MIL-L-3661/62C
AMENDMENT 3
15 SEPTEMBER 2003
SUPERSEDING
AMENDMENT 2
25 April 1991

MILITARY SPECIFICATION SHEET

LAMPHOLDER, LIGHTS, INDICATOR (HOUSING),
STYLE LH95 (FOR D.C. APPLICATIONS)

FIGURE 2. Wiring diagram

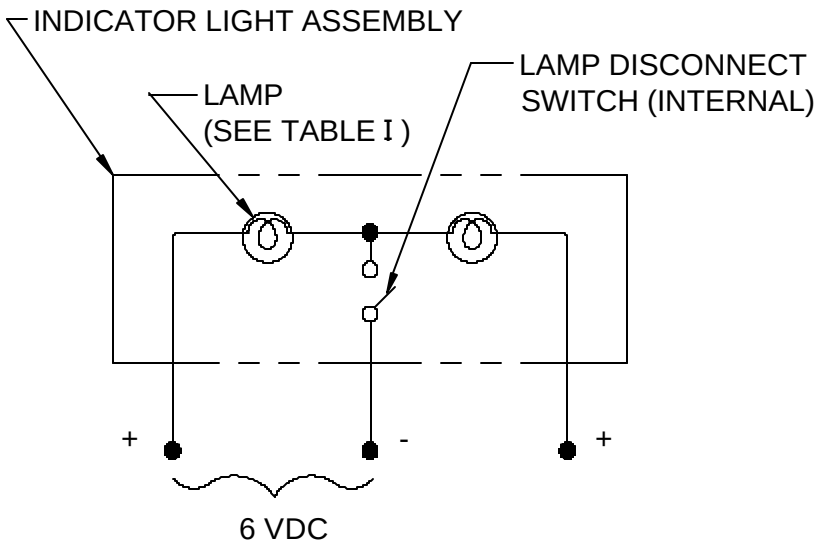
FIGURE 2: Delete and substitute:

FIGURE 5. Midget screw lamp socket.

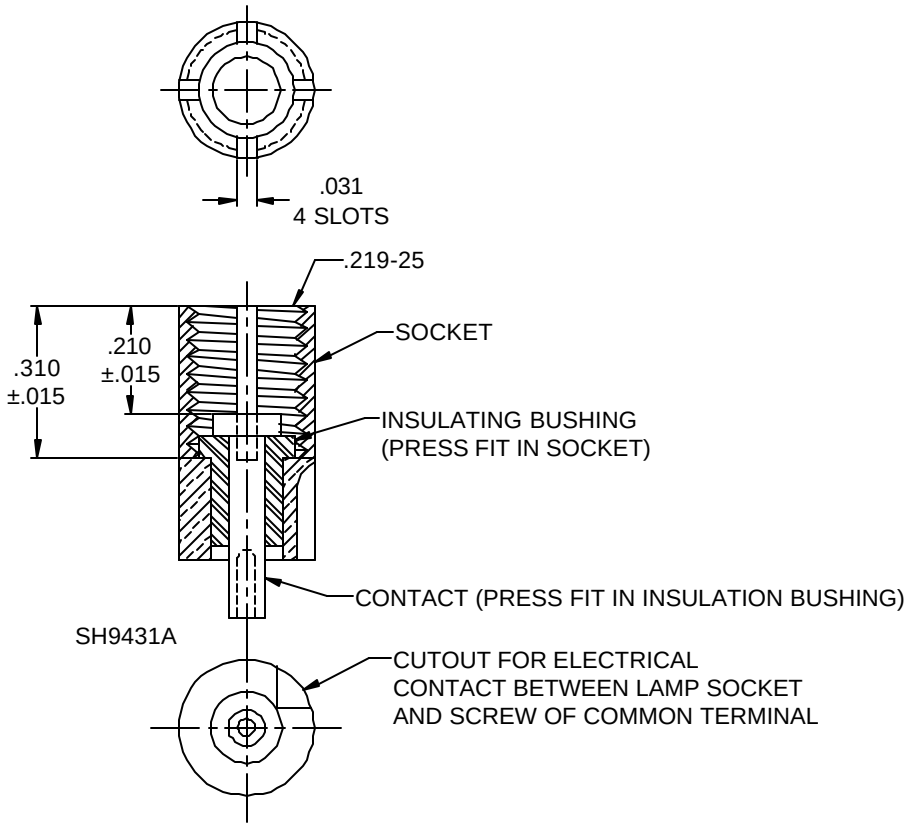
FIGURE 5: Delete and substitute:
